CITY of NOVI CITY COUNCIL

Agenda Item 3
January 23, 2017

SUBJECT: Approval of the request of TBON, LLC for a revised Preliminary Site Plan, Wetlands Permit and Stormwater Management Plan. The request is for an expansion of the existing showplace exposition facility by adding a 172,315 square foot building addition, with associated parking lot and other site improvements for land within the OST, Planned Office Service Technology District, and in the OST, Planned Office Service Technology District with an EXO, Exposition Overlay District. The subject property is located in Section 16, north of Grand River Avenue and west of Taft Road.

PLAN REVIEW CENTER REPORT

SITE PLAN

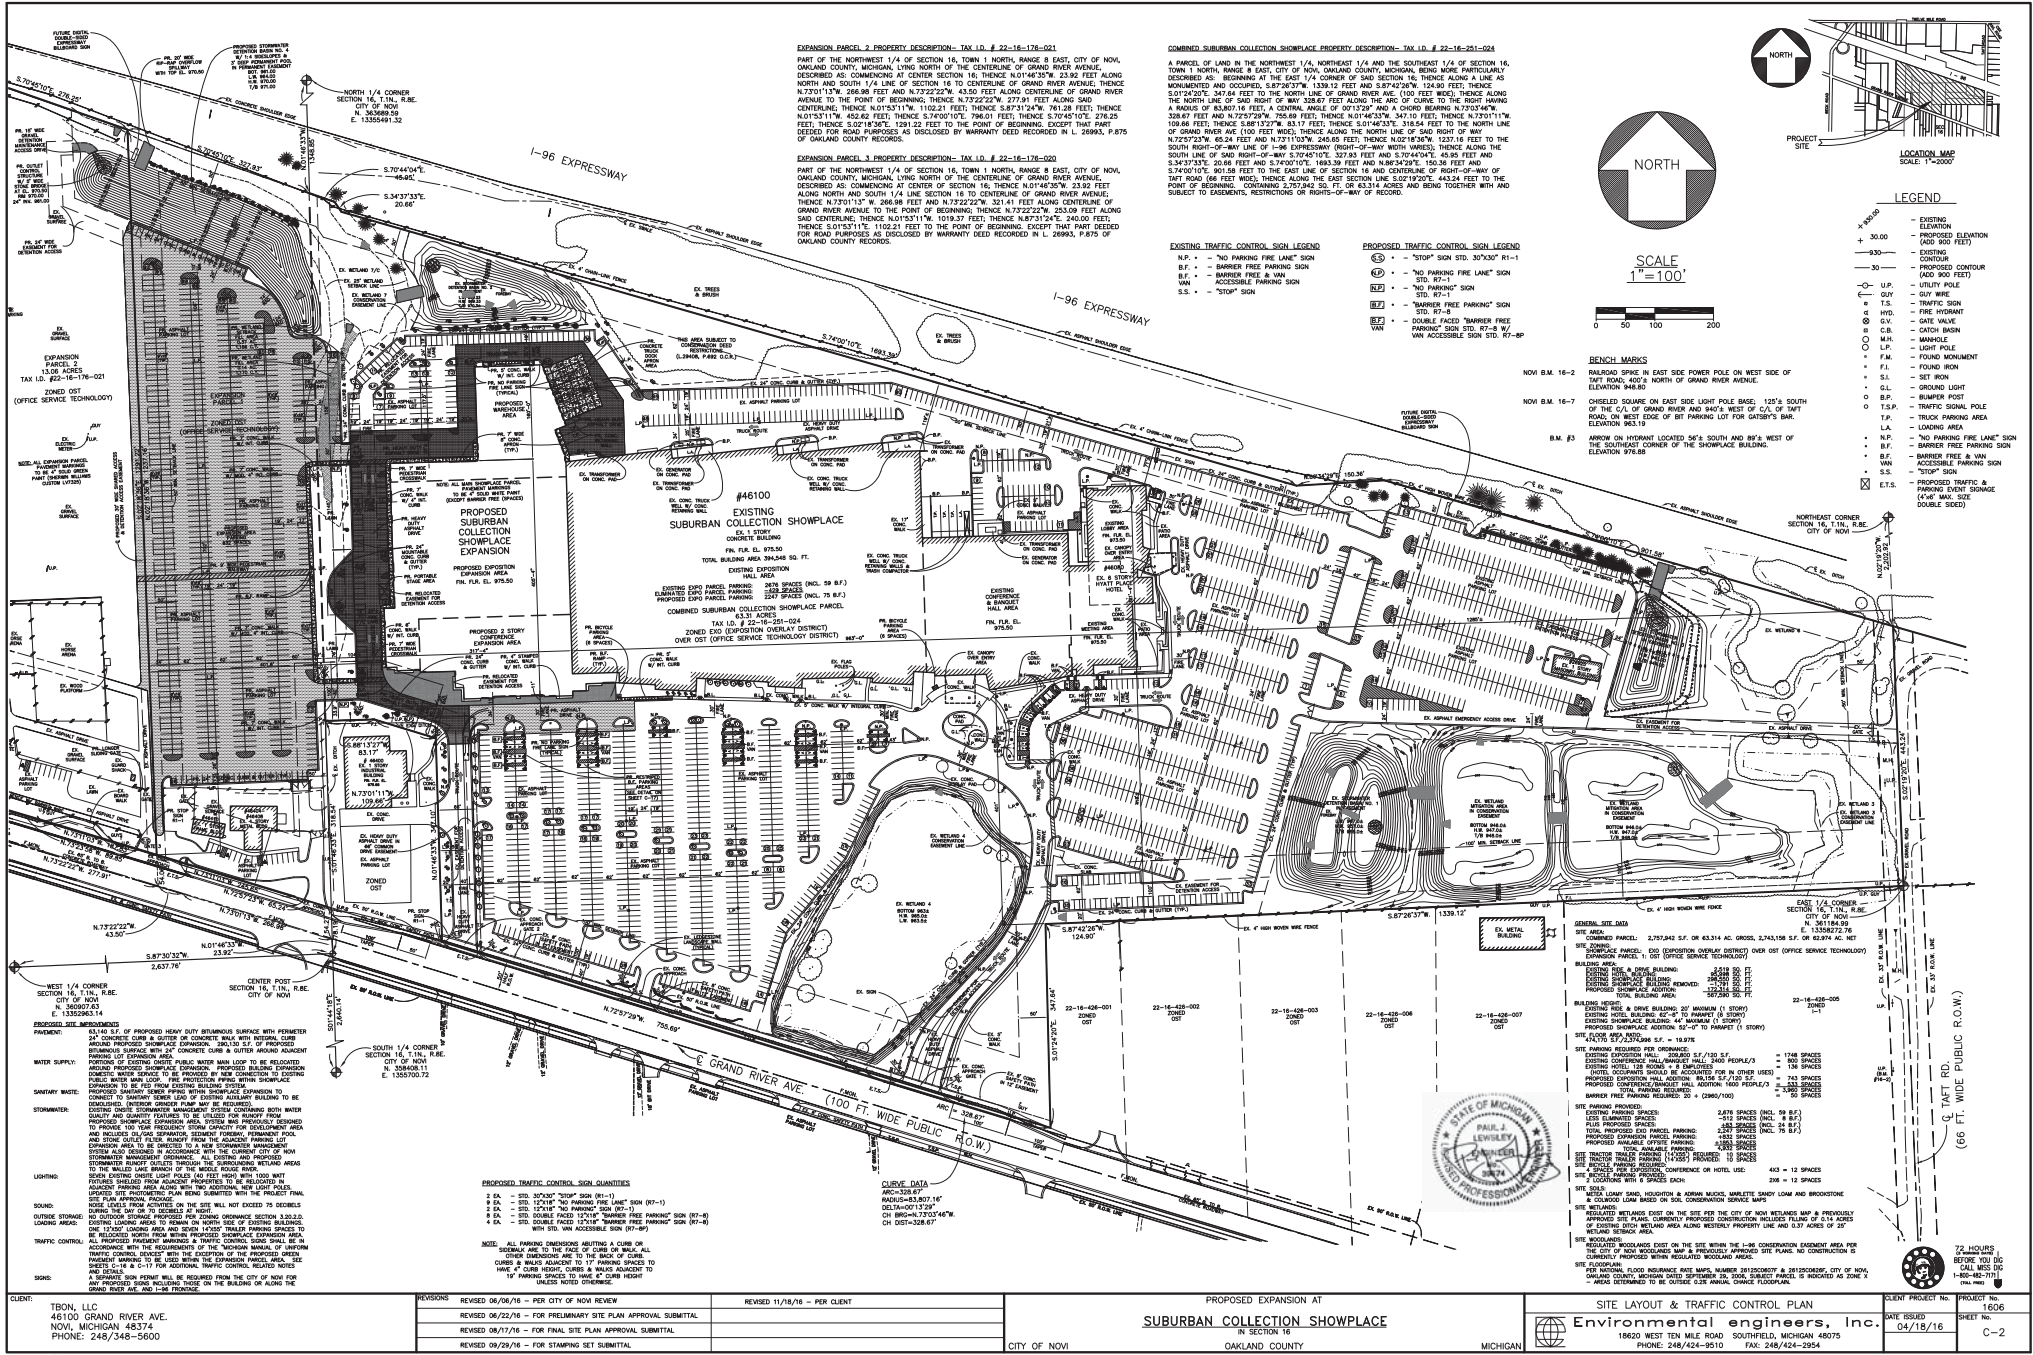
5. Building setback deviation: *The side setback* for EXO districts is 50 feet or the height of the building. The height of building is indicated as fifty six feet on the proposed elevation (maximum height of existing building is 62 ft.). The revised building footprint is exactly on the fifty foot setback line, thus deviating by 6 feet from the minimum required. Previously approved Zoning Board of Appeals Variance only includes deviations from the front building setback. **The applicant should either revise the footprint to conform to the requirement or apply for a Zoning Board of Appeals variance.**

3. Additional Deviations: **Refer to additional comments in page 2 with regards to building setback, façade and landscape deviations.**
4. Lighting Plan: Please refer to the chart for additional details.

PREVIOUSLY APPROVED LAYOUT

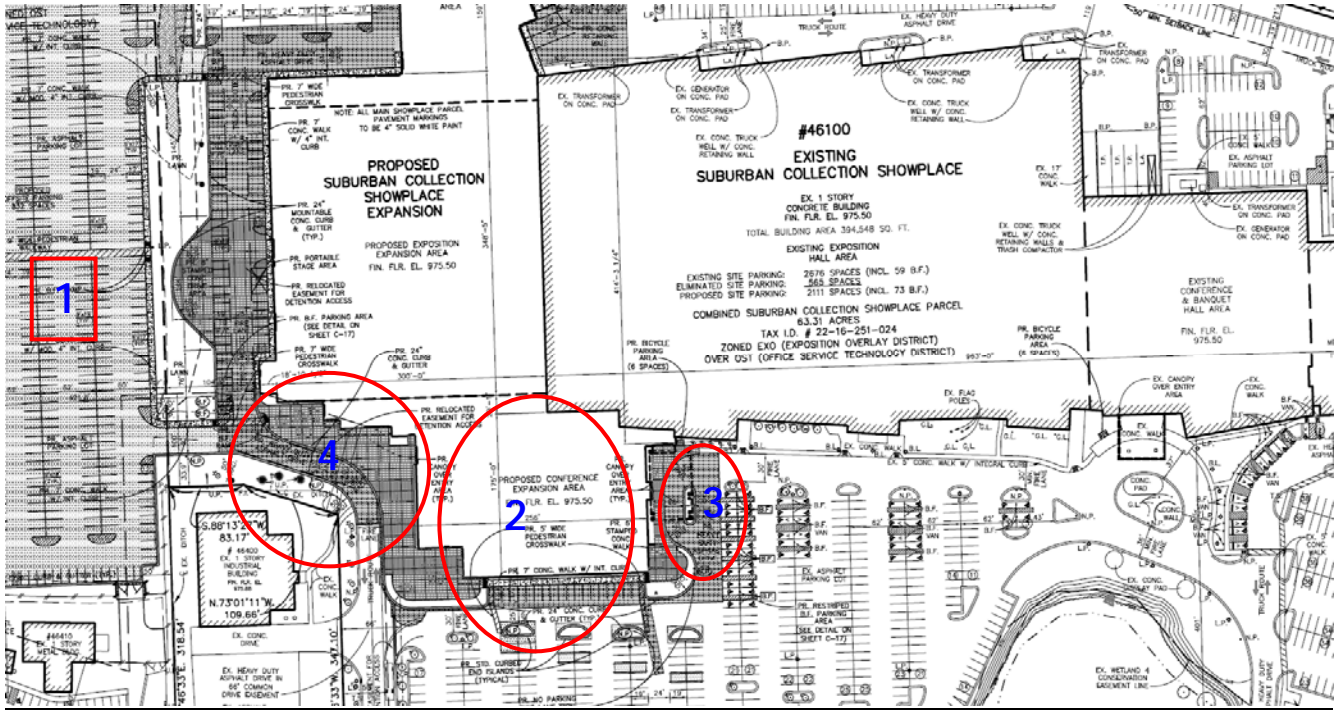
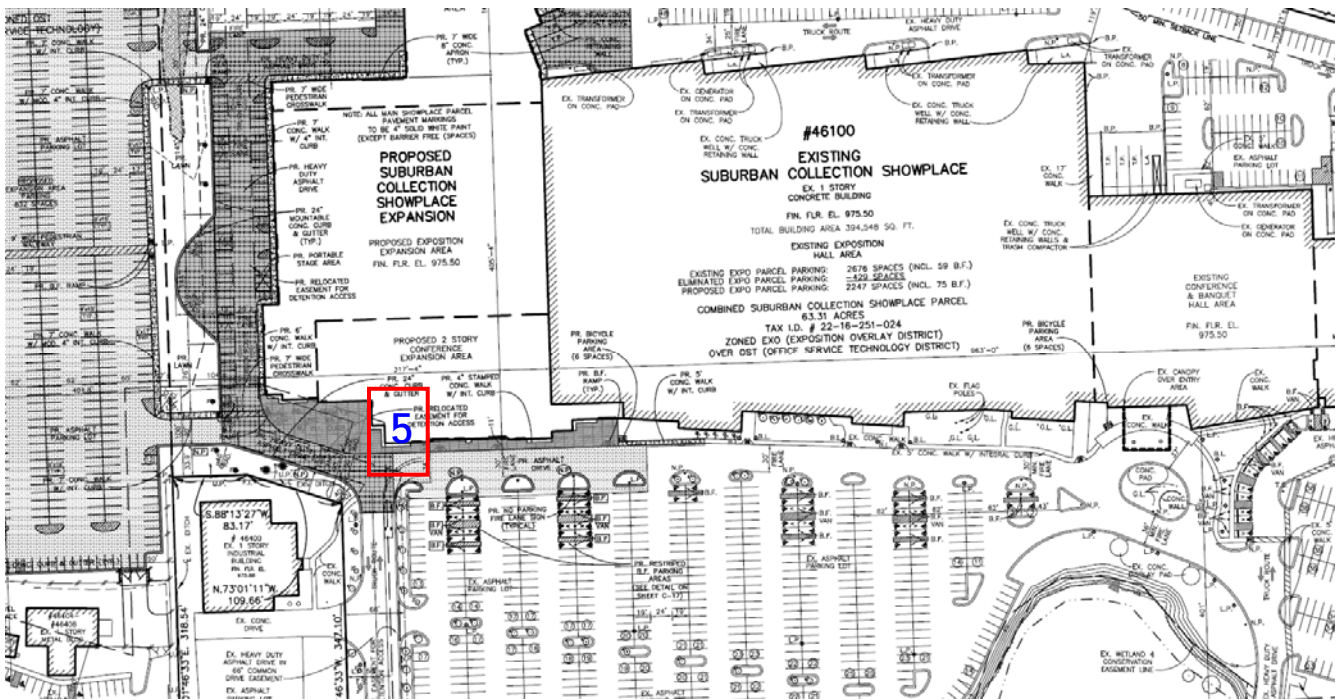
The applicant received final stamping set approval on **October 20, 2016**. The applicant is now requesting to approve the revised site plan. The following changes have been made from previously approved site plan.

2. Building footprint: The building projection from the approved plan is now replaced with additional parking spaces. Building façade line in the current plan aligns with the existing façade line.

3. Drop-off Area: The drop-off area to the east of the previously approved building footprint is now replaced with additional parking spaces.
4. Outside Patio Area: Due to change in building footprint design and addition of parking spaces, the amount of outside patio area in the south west corner of proposed addition, similar to those found near the Hyatt Hotel on the east side of the site, has been reduced considerably.

9. Parking Count: A total of 136 additional on-site parking is proposed on EXO site. (Approved 2,111 spaces, current revised 2,247 spaces)

Figure 1. City of Novi Regulated Wetland & Woodland Map (approximate project location shown in red). Regulated Woodland areas are shown in green and regulated Wetland areas are shown in blue). Approximate overall project boundary is indicated in red.

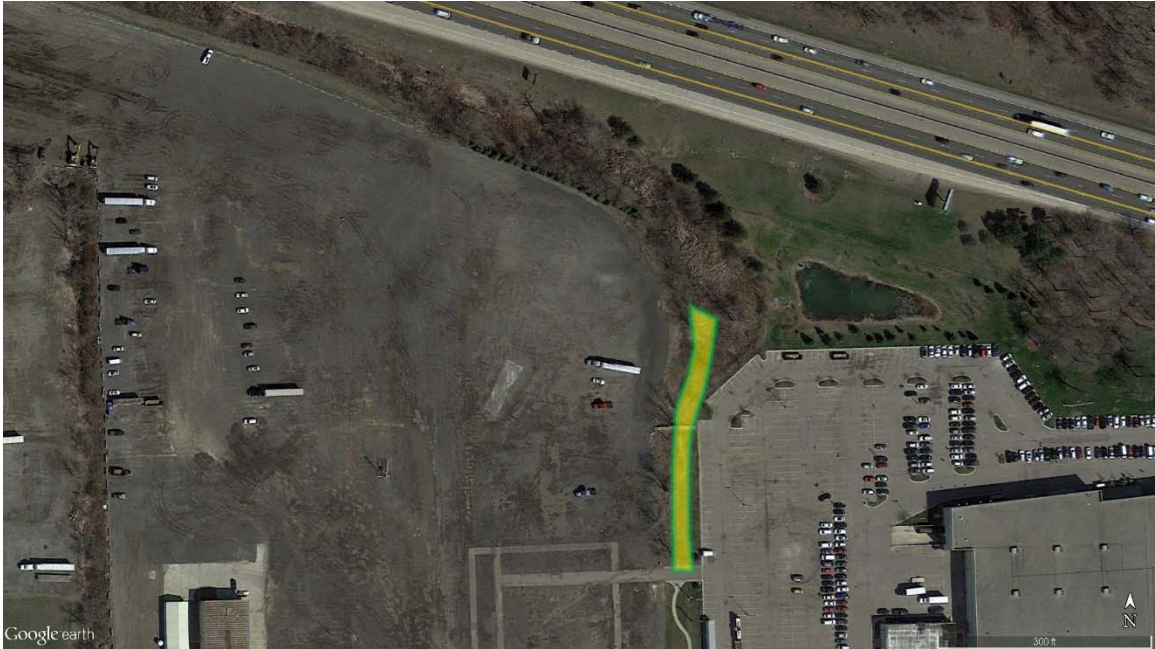
Based on our review of the application, Novi aerial photos, Novi GIS, the City of Novi Official Wetlands and Woodlands Maps (see Figure 1, attached) it appears as if this proposed project site is adjacent to City-Regulated Woodlands and contains City-Regulated Wetland areas.

ECT visited the site on April 22, 2015 as well as on July 6, 2016 for the purpose of a wetland boundary verification. The focus of the inspection was to review site conditions in order to determine whether on-site wetland is considered regulated under the City of Novi's Wetland and Watercourse Protection Ordinance. ECT reviewed the wetland area (Wetland 7/C) at the proposed project location. The approximate project boundary is depicted in Figure 1.
